FIELD SERVICE BULLETIN

FSB Number: LVCCFSB2006-044
Authors: Darwin Garcia
Date: February 16, 2006
Total No. of Pages: 4
Subject: **V3 Main LCD Dust Ingress**
Model Affected: **V3**
Level of Repair: 2

Problem

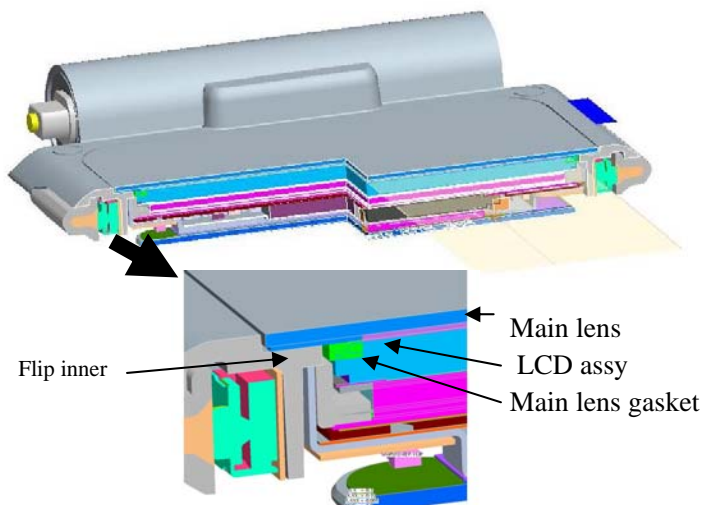
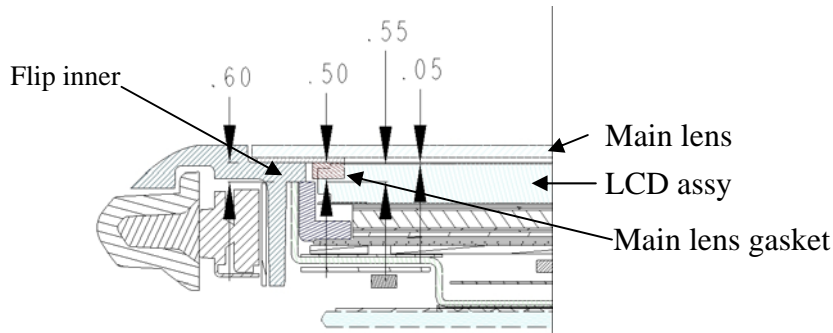
Service has been made aware of a V3 Sharp main LCD dust ingress issue that could cause “Display Main - Dust” complaints.

Contamination on the displays is predominantly dust and cellulose fibers. These are common environmental materials to which the product will inevitably be exposed during field use.

The root cause was glass position within LCD module being lower (away from dust seal) in Sharp displays (7290086N02) due to its stack-up being lower than specification causing less gasket compression which allowed dust to penetrate the seal.

Display Identifiers:

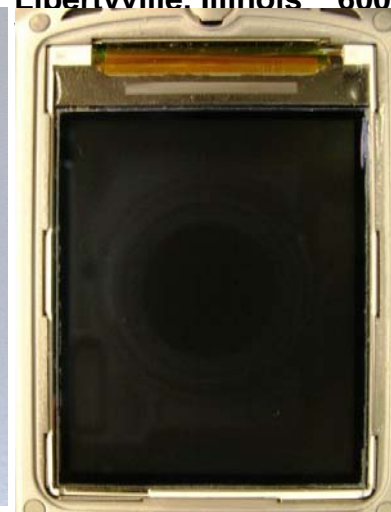
When removing the main lens, Sharp is the only vendor with a label on the display driver IC.

7290086N02
Note the label on display driver
Supplier: Sharp

When servicing any V3 customer phones with described issue remove the main lens and identify the vendor, if it is Sharp replace the main lens (1 = 6190016N06), if is not replace with (1 = 6190016N03).
